**FIGURE 1:
CURRENT APPROVED TOPOGRAPHY**

RE: (EXTERNAL)M-1980-244 TR-121 Map Scale Follow-up

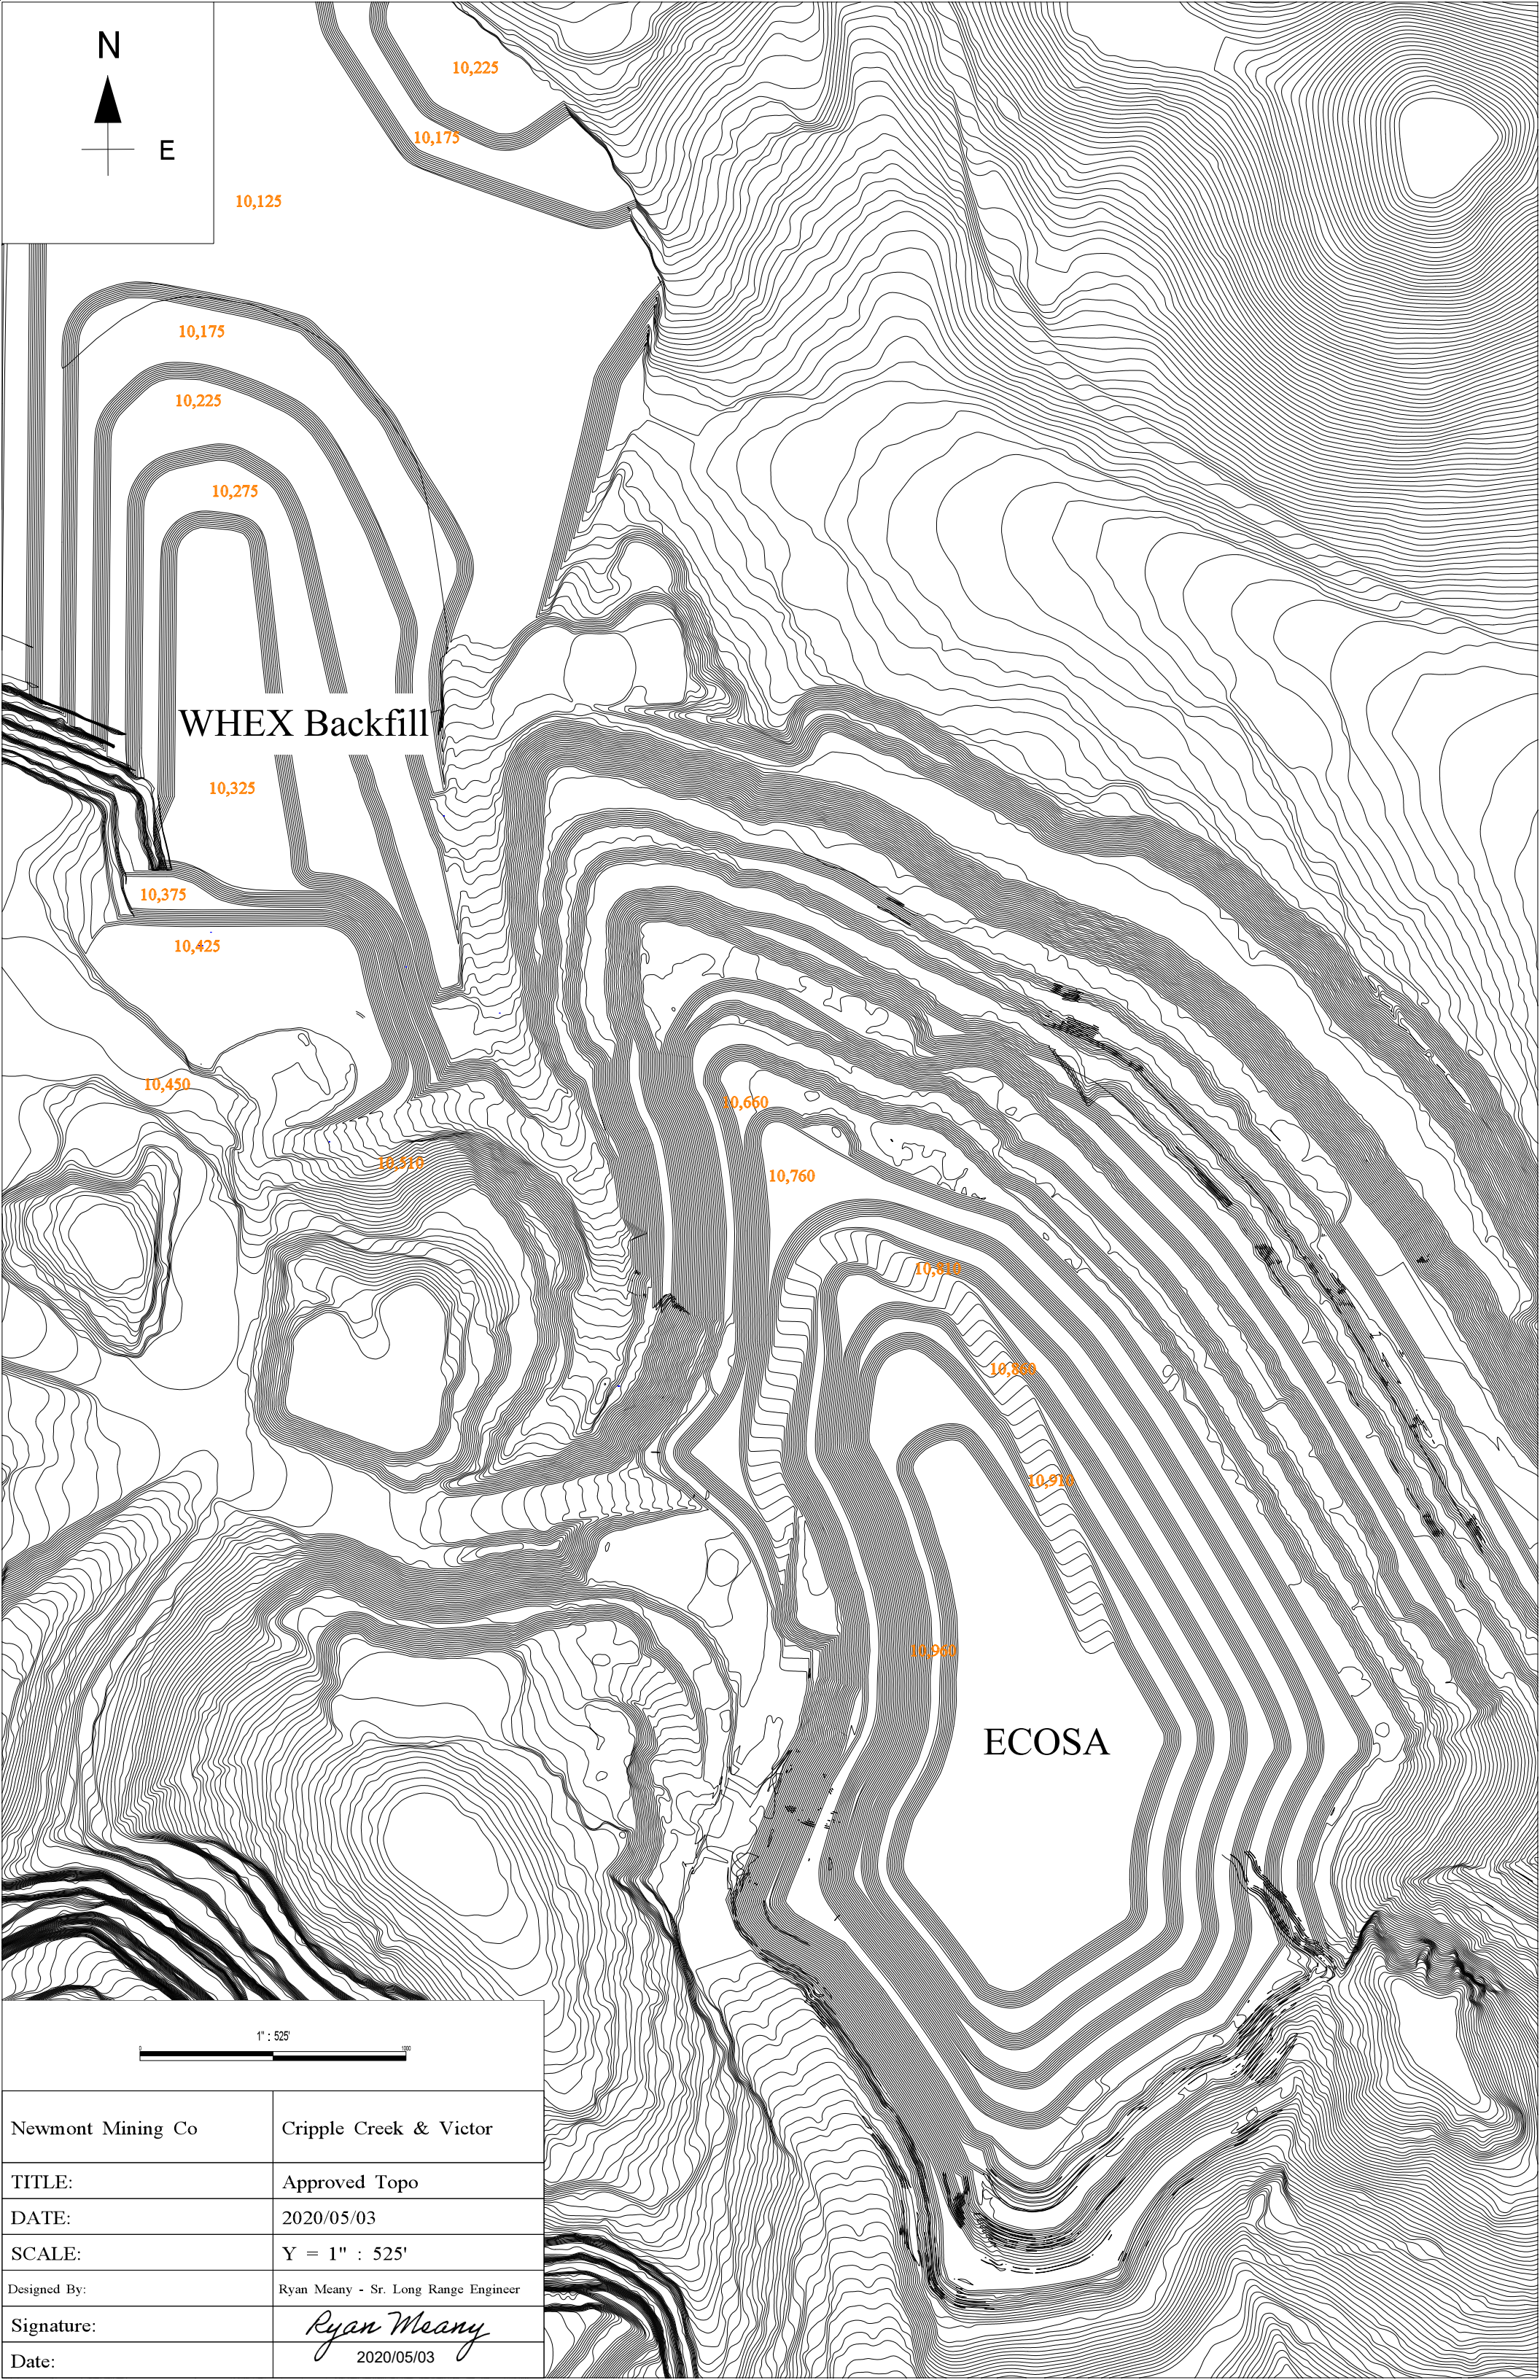
I'm still confused on the scale issue. I took a look at the maps in your emails and did some calculations. Based on Google Earth measurements the long axis of the ECOSA (from the south end of the WHEX to the south end of the OSA) is roughly 7,000 ft and from Grassy Valley to the haul road on the west side of the ECOSA is less than 4,000 ft. Using a scale of 1" = 660' one needs a paper space of 10.6 inches by a smidge over 6 inches. That should easily fit on a sheet of 11 x 17 inch paper (or B size drawing) and still allow for a 1/2-inch margin.

It looks like the maps are on A-size or 8 1/2 by 11 inch paper size. Why can't your map guy set up the maps on larger "paper"? I assume he/she is doing this all electronically anyway and not constricted by a home printer limitation.

We have updated the figures to meet scale requirements. I am sending each figure and cover page as a separate email (as I did with the initial submission on 4/30) due to the large file size. Please let me know if you'd like me to include the whole ec group on these. Also, do you know if our check was received yet?

Please see Figure 1, Current Approved Topography attached.
